FINAL DRAINAGE REPORT FOR SADDLEHORN RANCH – FILING 2

> November 18, 2022 Project No. 25142.04

El Paso County PCD File No.: SF-21-033

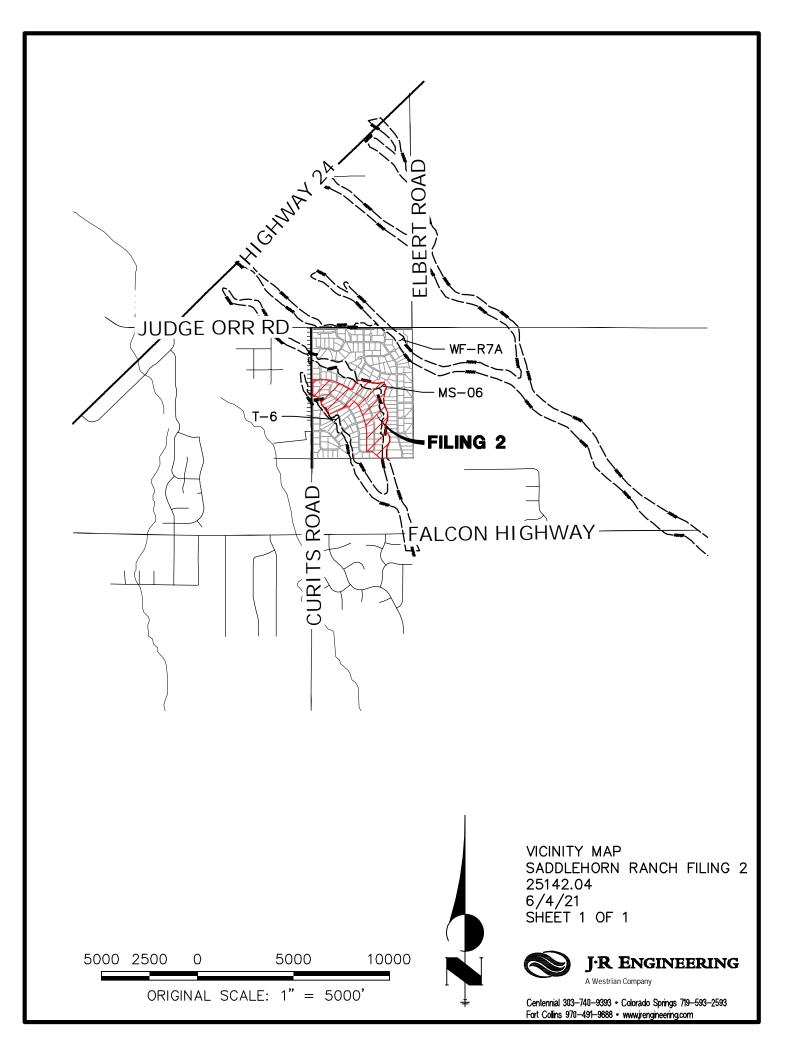
Remove or revise this portion if channel improvements are not being built until Filing 3.

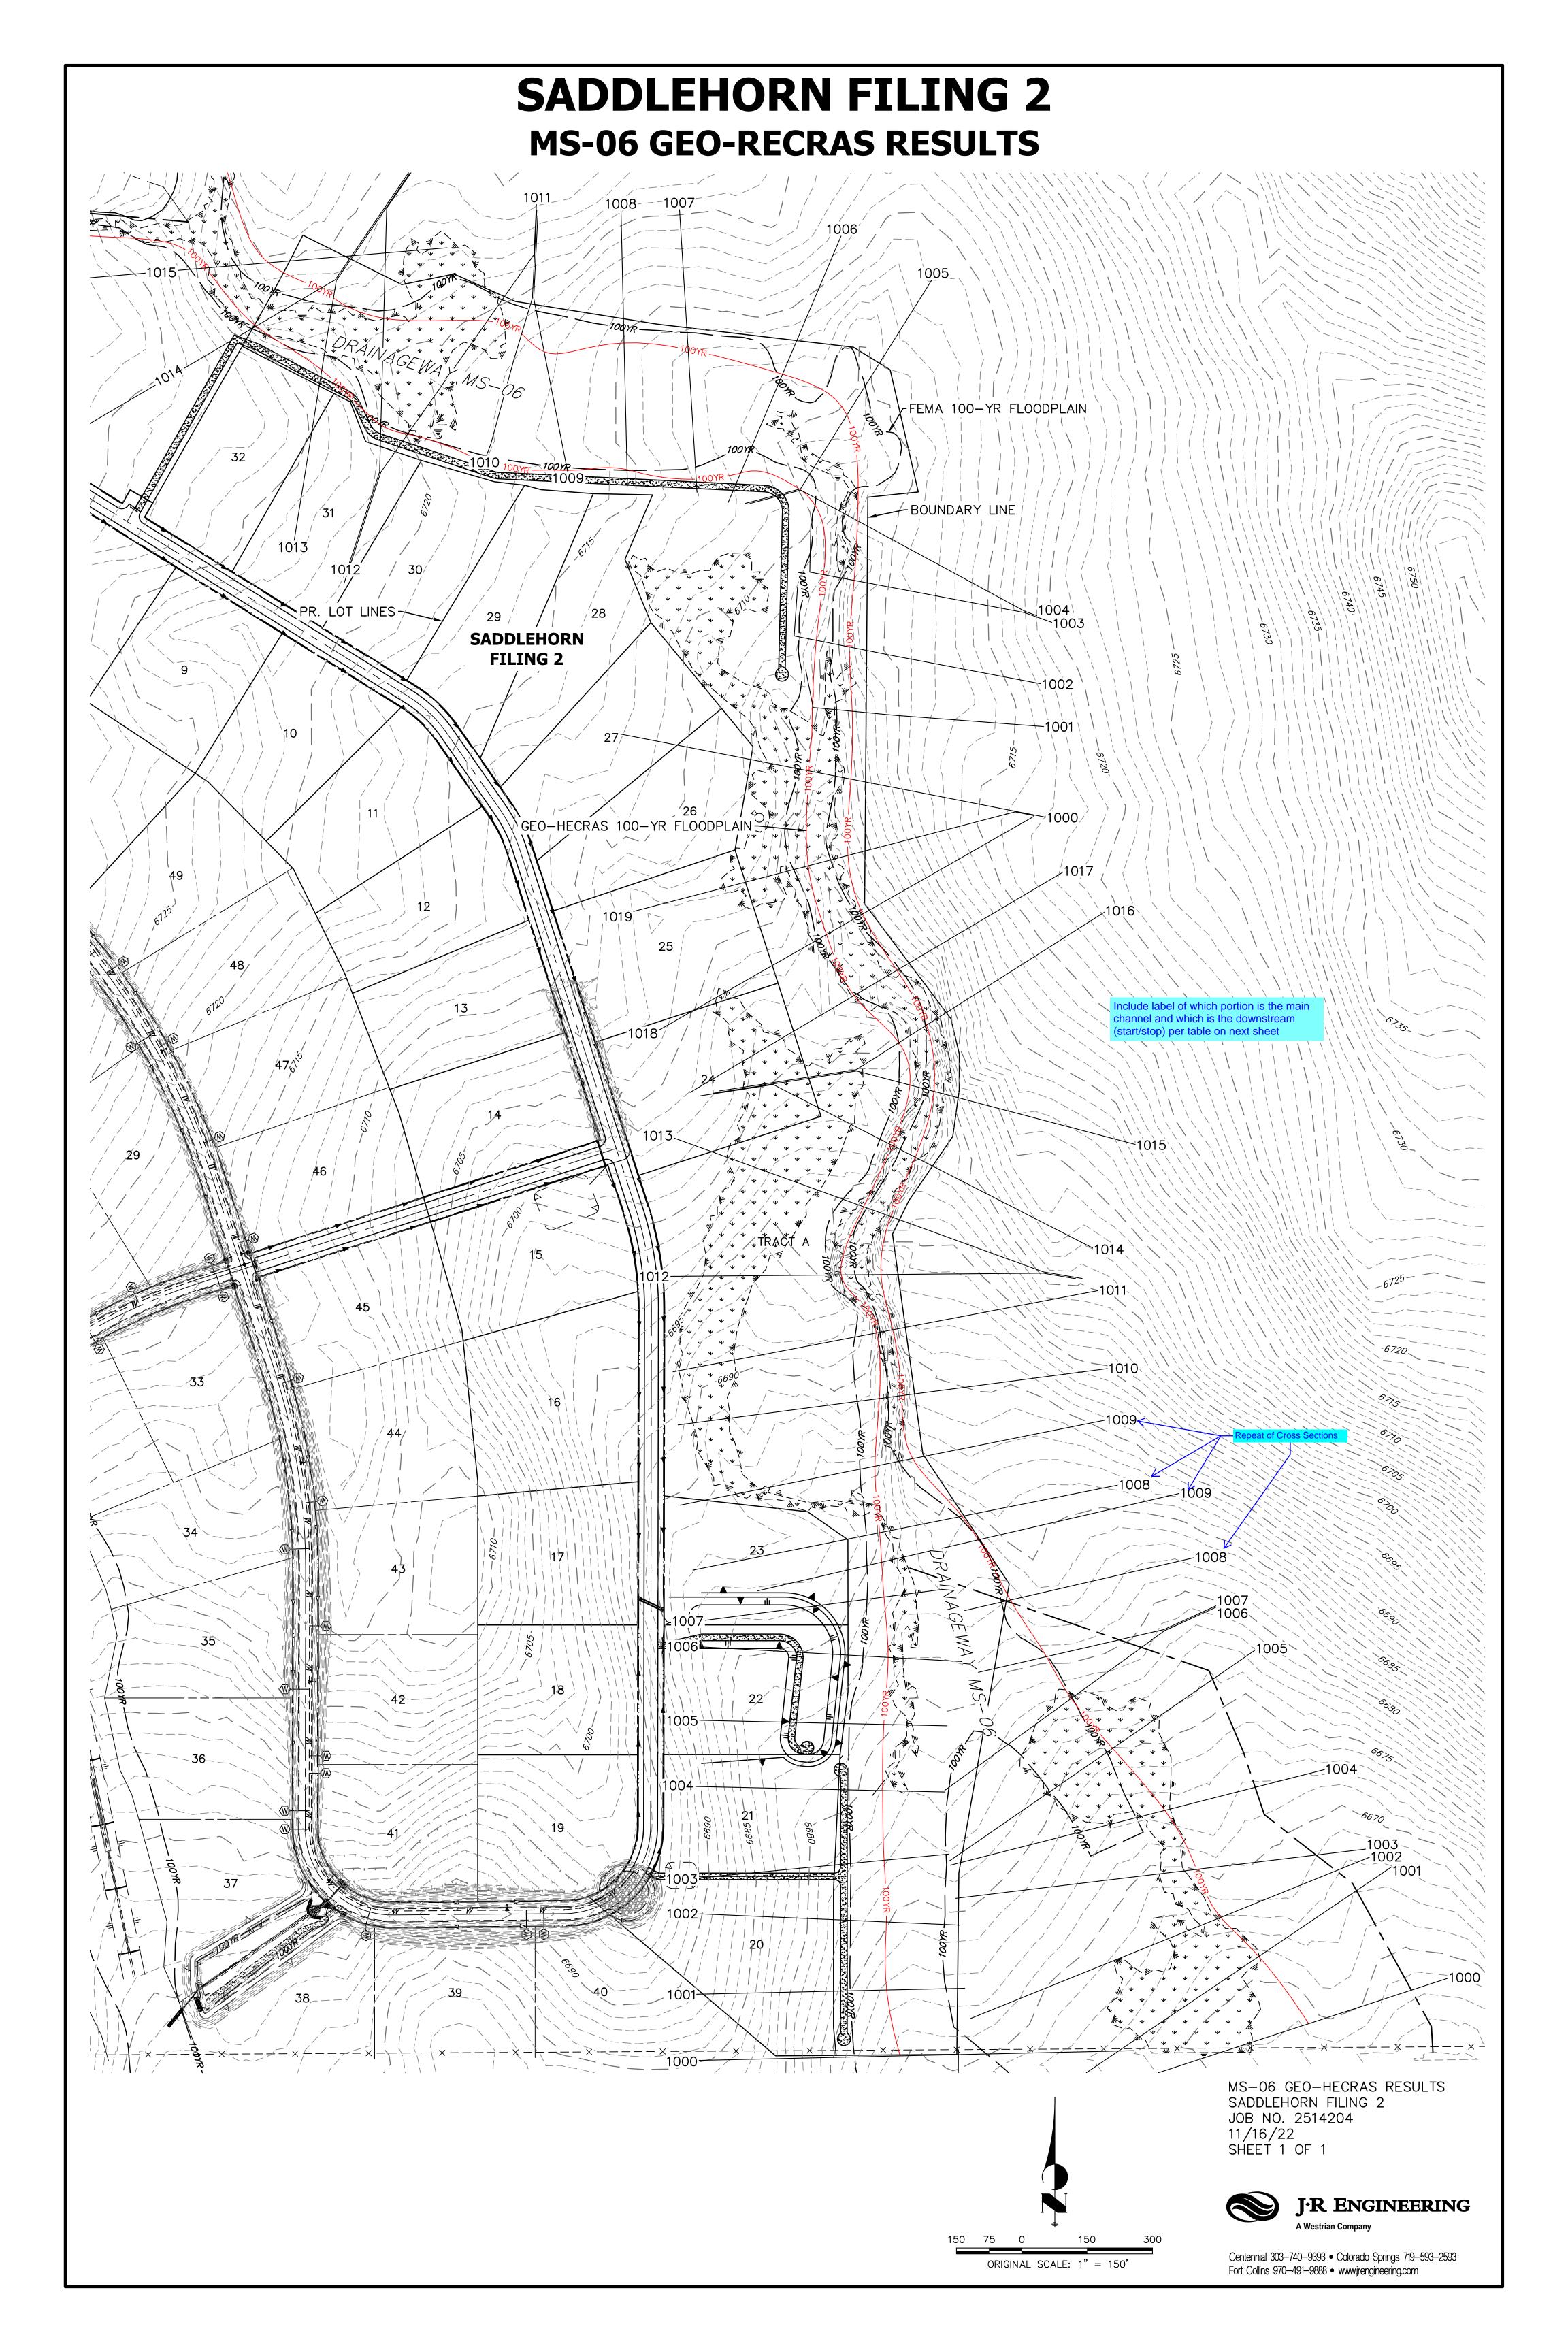
Label this structure on the map on the previous page

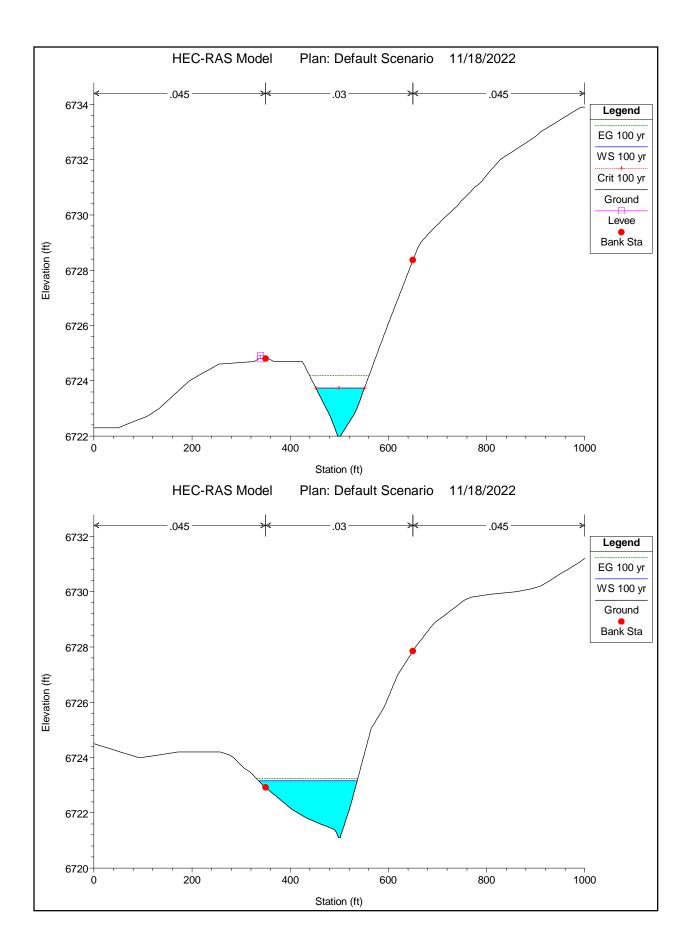
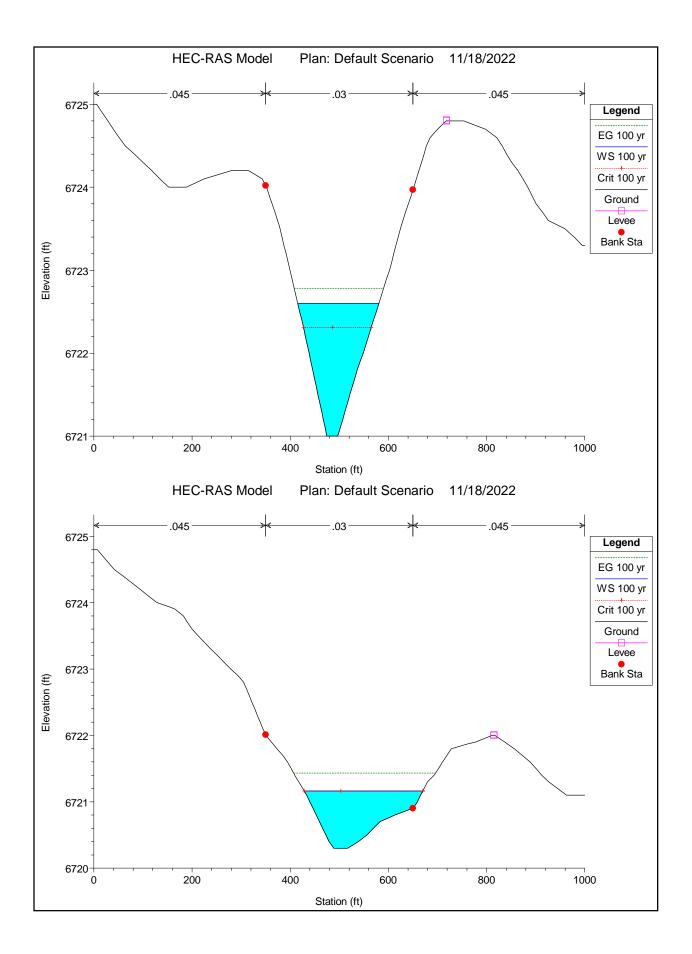
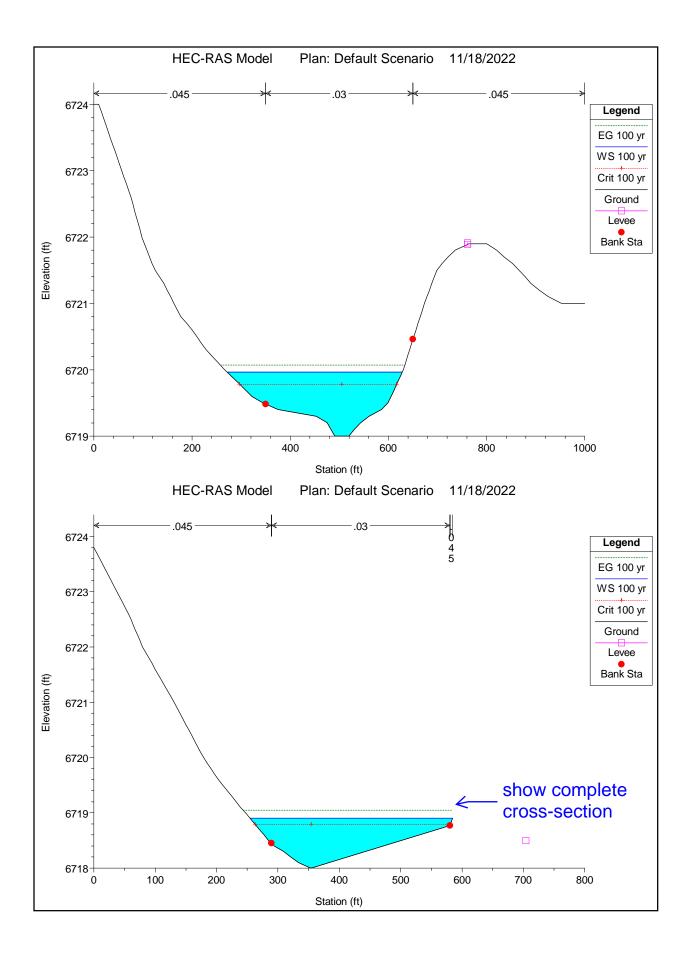
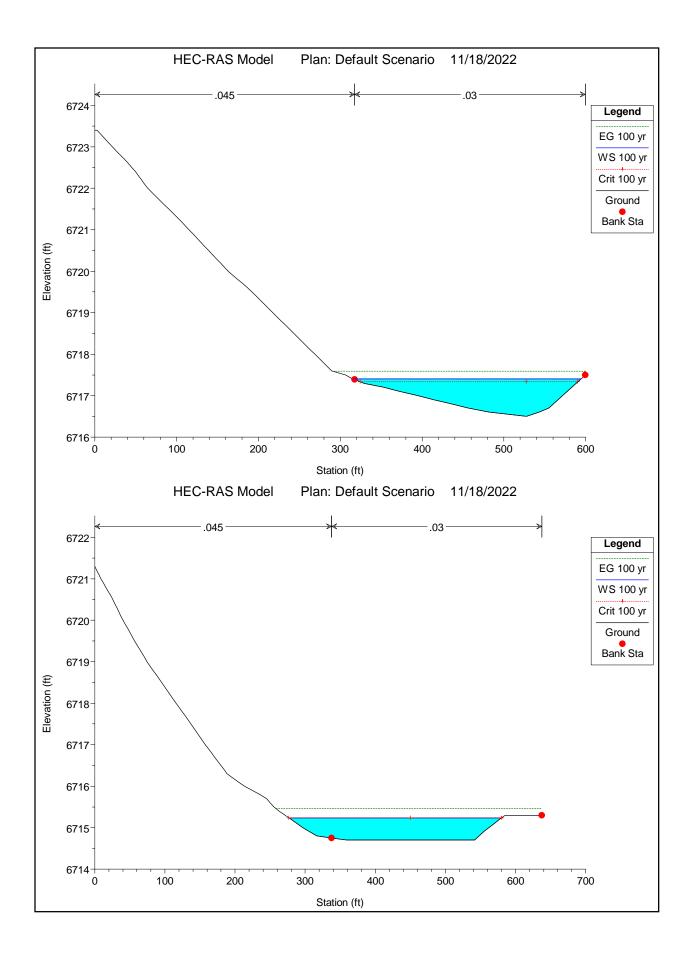
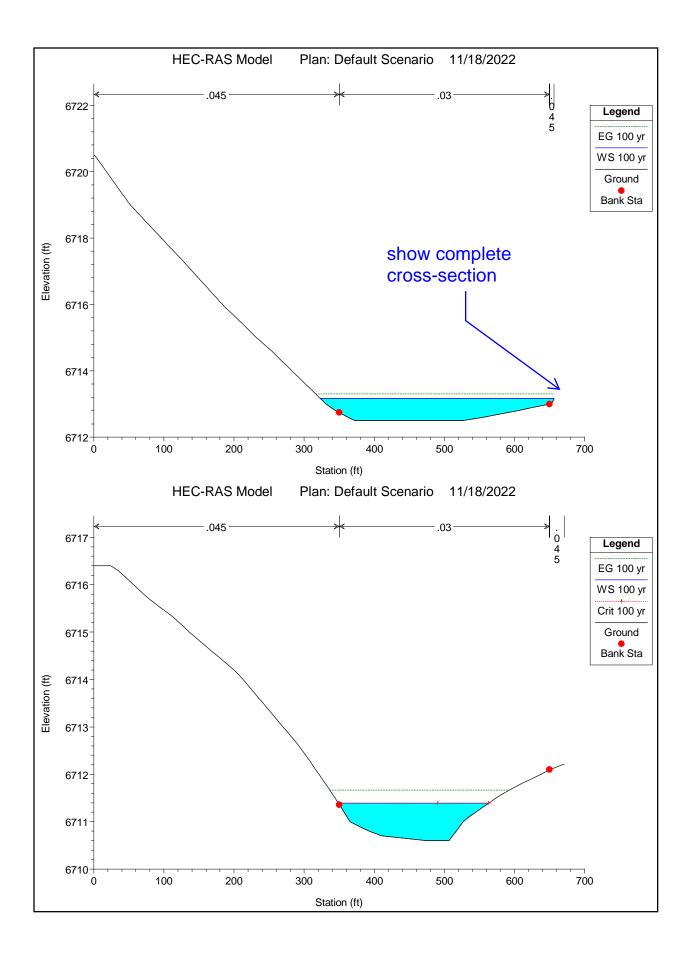
Include copy of HEC-RAS input report & channel profile.

Highlighted values are above permissible velocity. How are excessive velocities being mitigated within channel. Highlighted values are where Fr # is in excess of allowable. Indicate what mitigation is being done in these super critical areas.
